RESPONSE TO SUBMISSIONS LETTER - TRAFFIC/VEHICLE MOVEMENTS

TTPP REF: 16222

RE: Proposed Resource Recovery Facility, 20 Hearne Street Mortdale (SSD 7421)
Response to Submissions

Vehicle Stacking Plan (Waste Delivery Vehicles)

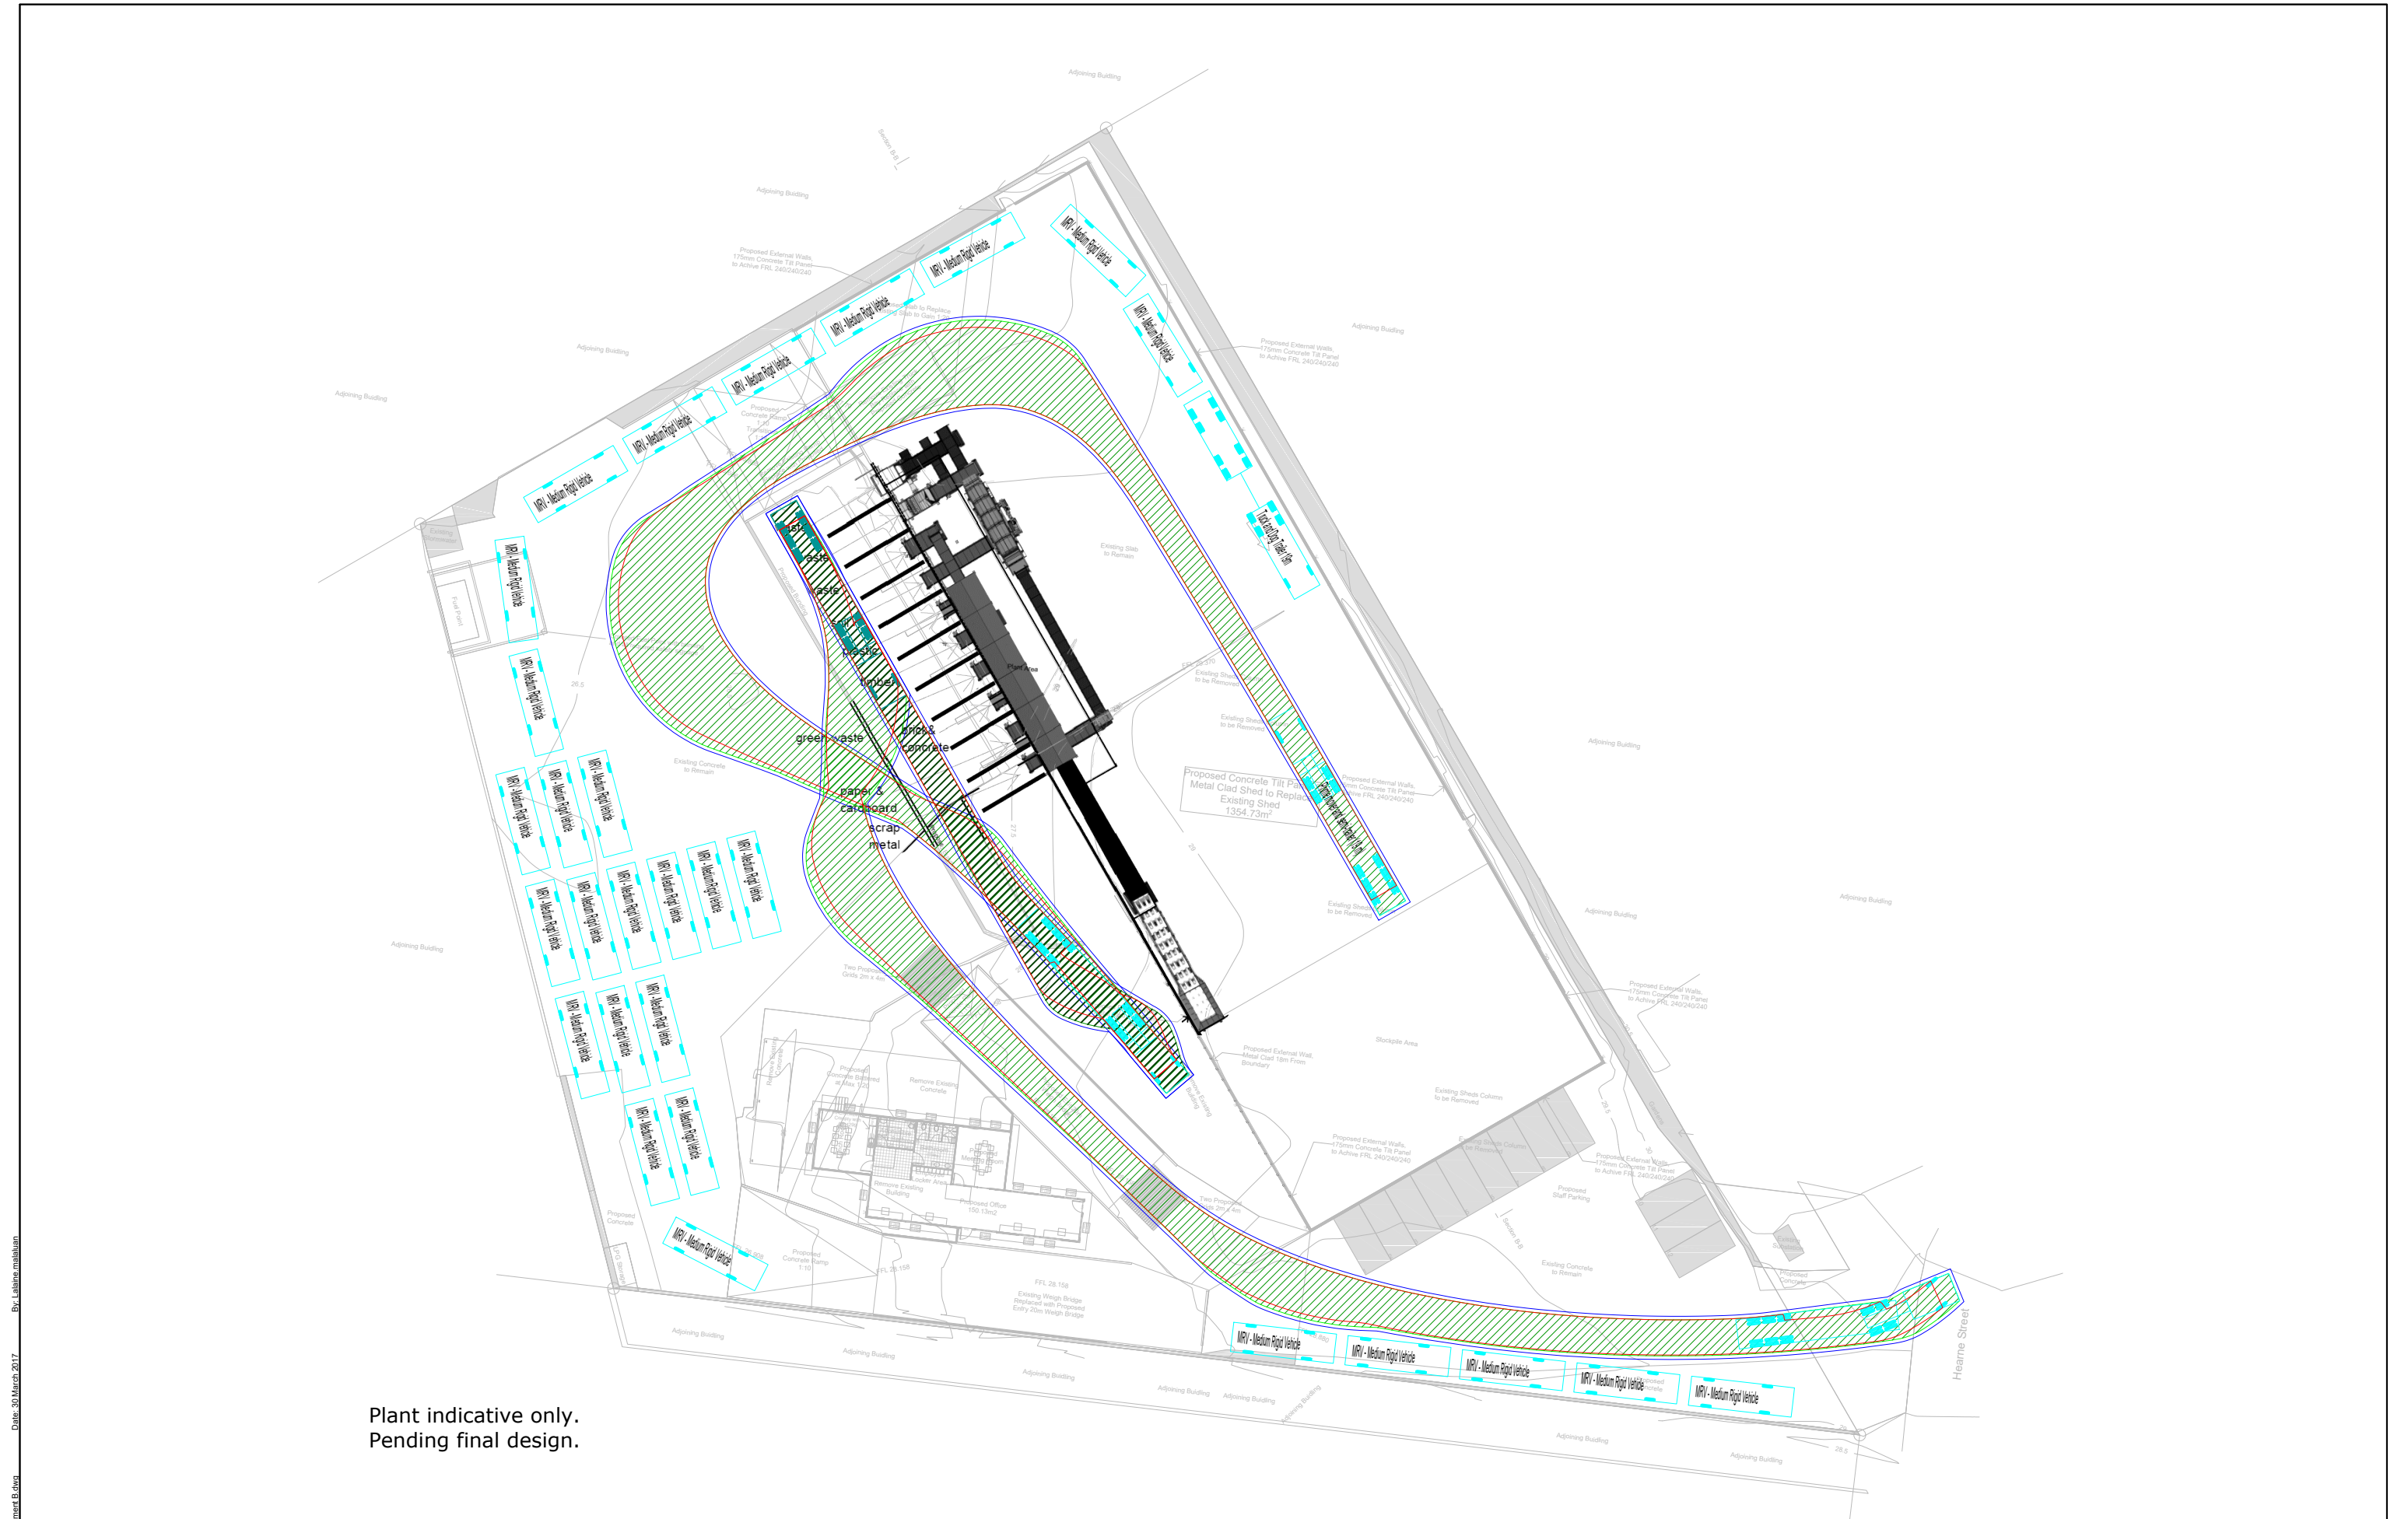
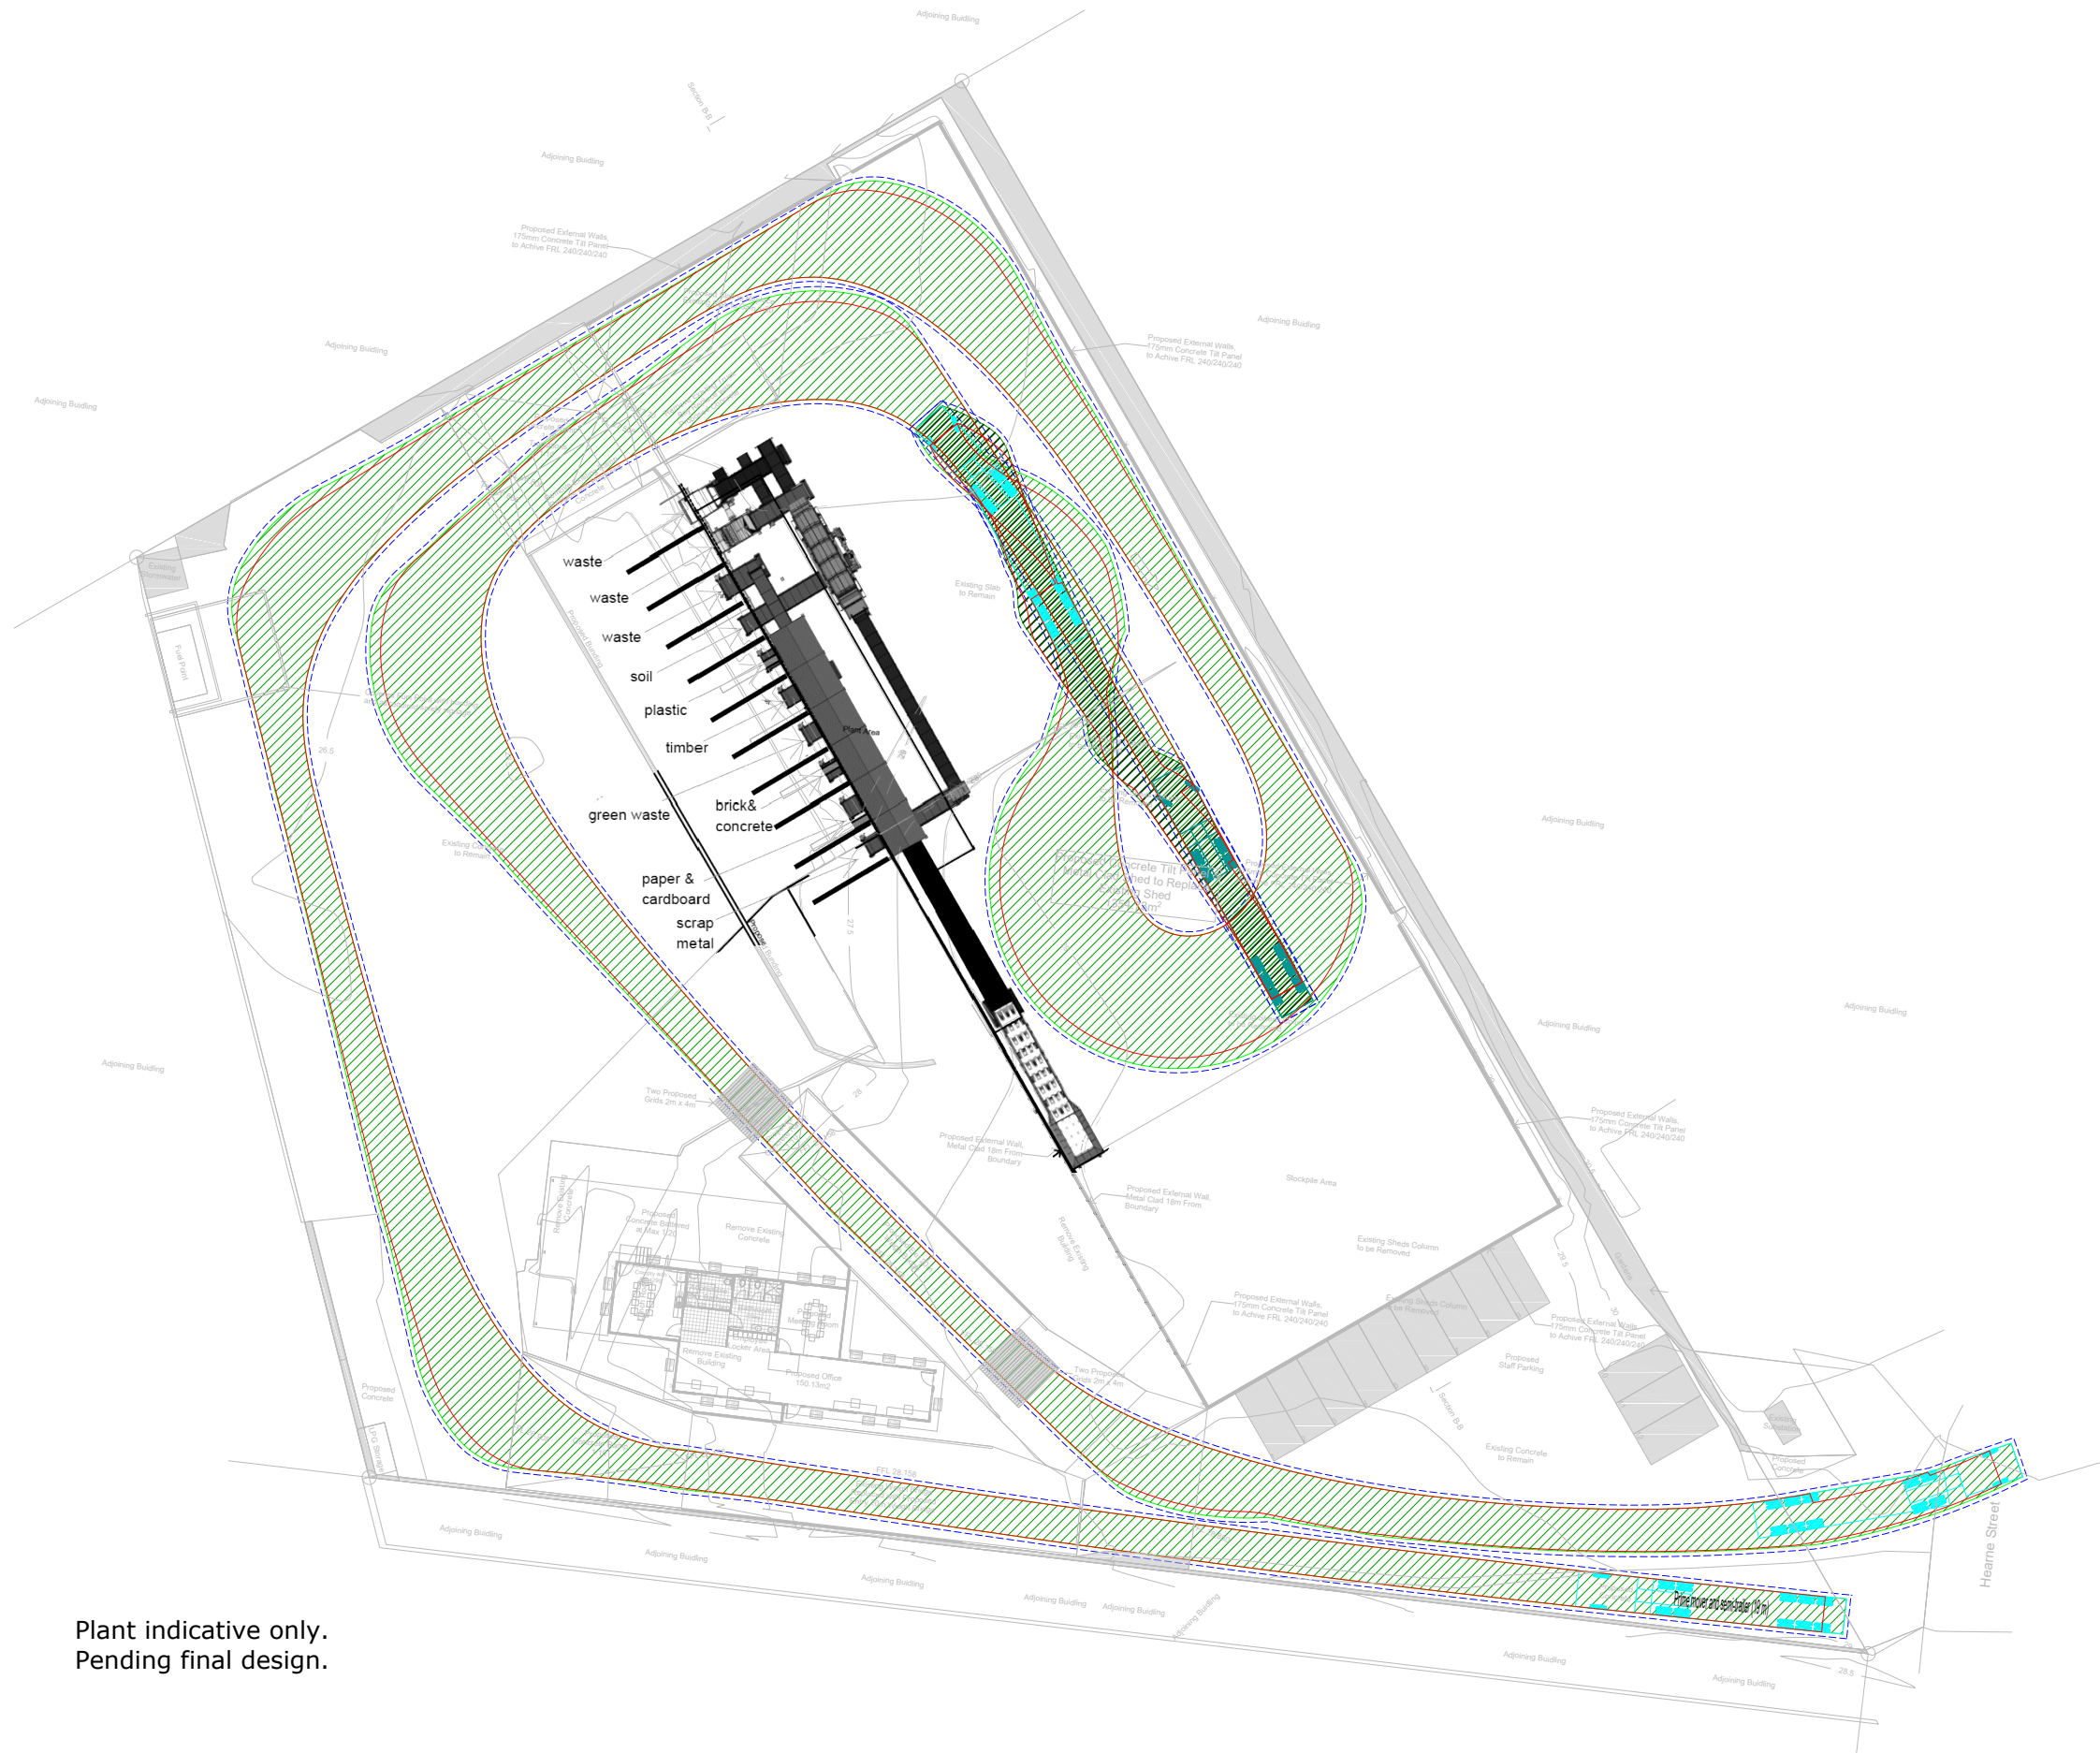
Exiting trucks have been placed in a location which contradicts the stacking plan diagrams. This requires amendment.

The stacking plan has been amended accordingly, and is provided in Attachment B and Attachment C. Vehicle swept paths at the site access are shown in greater detail in Attachment D.

Vehicle Stacking Plan (Waste Collection Vehicles)

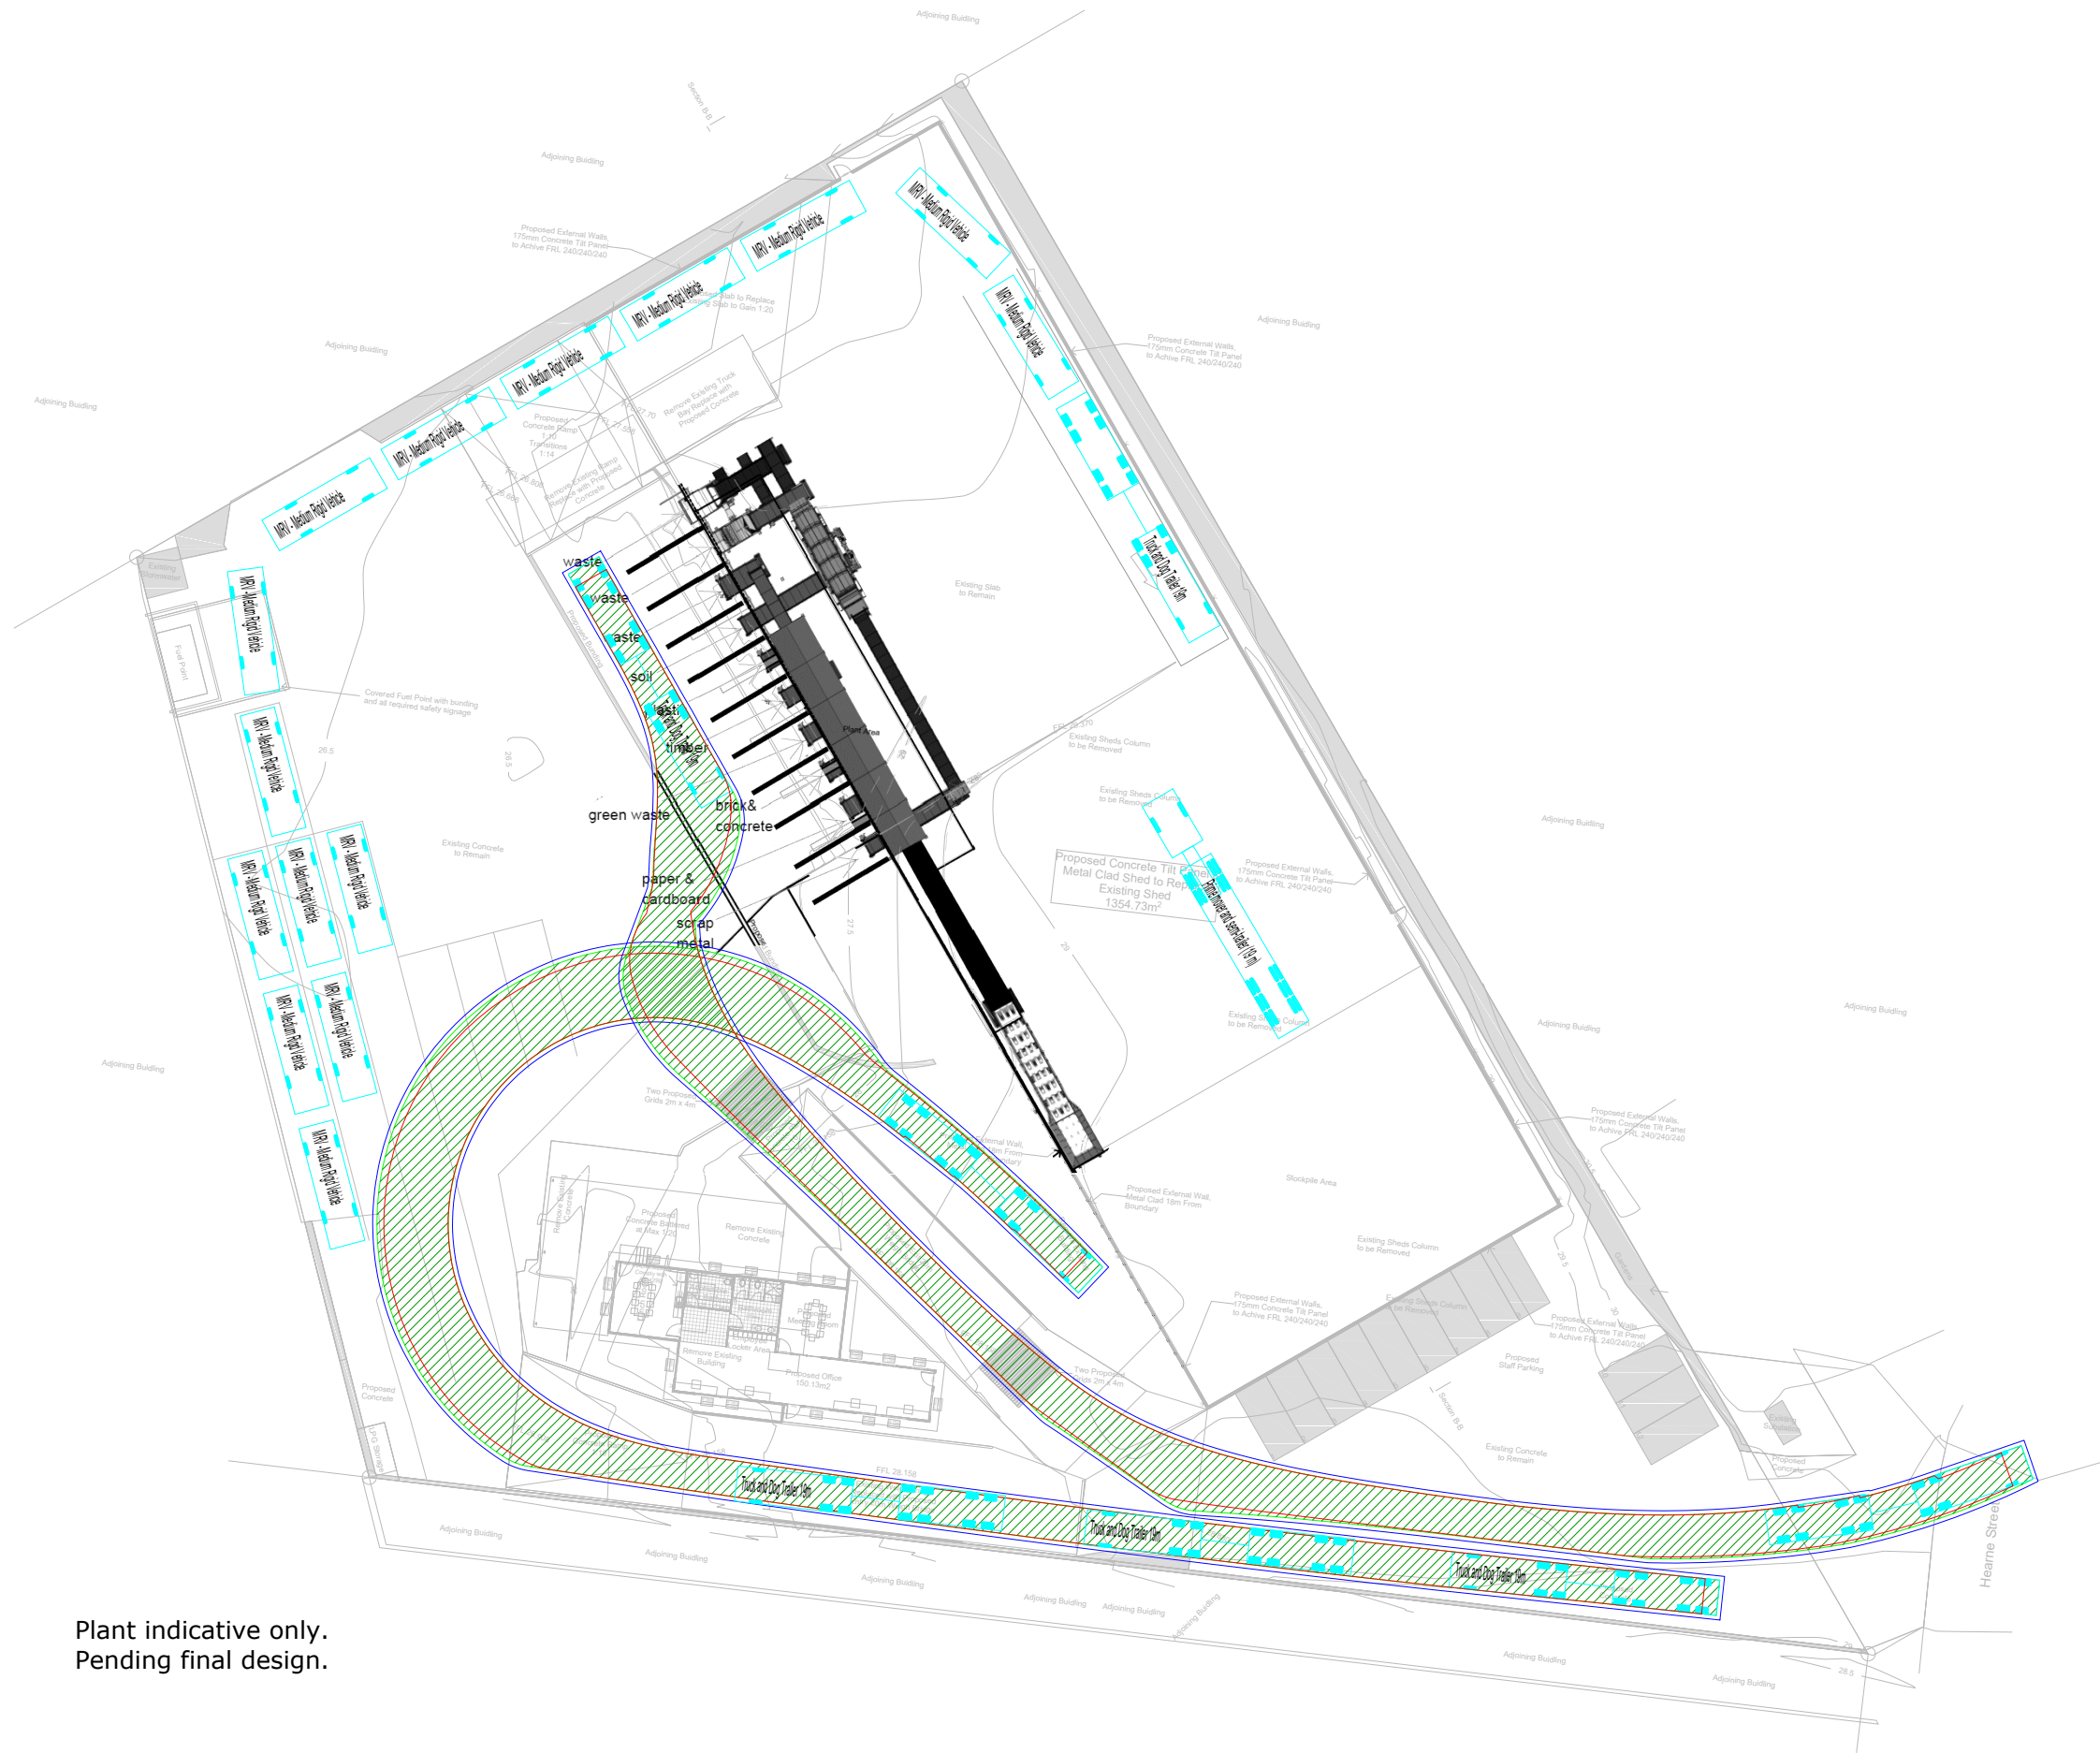
A stacking plan has been provided which only shows the stacking of heavy rigid trucks on site. There is no plan showing the stacking of semi-trailers collecting sorted materials. There is no indication of how traffic will be controlled at the access way. In particular, how will trucks be directed to the stacking locations. Further, the stacking plan contradicts the internal turning path diagrams with vehicles stacked in areas required for manoeuvring. Further clarification is required.

A stacking plan showing the larger waste collection vehicles (semi-trailers and truck-and-dogs) is provided in Attachment C. The stacking arrangement and level of adequacy is discussed in detail in the response to *Council Item 5*.
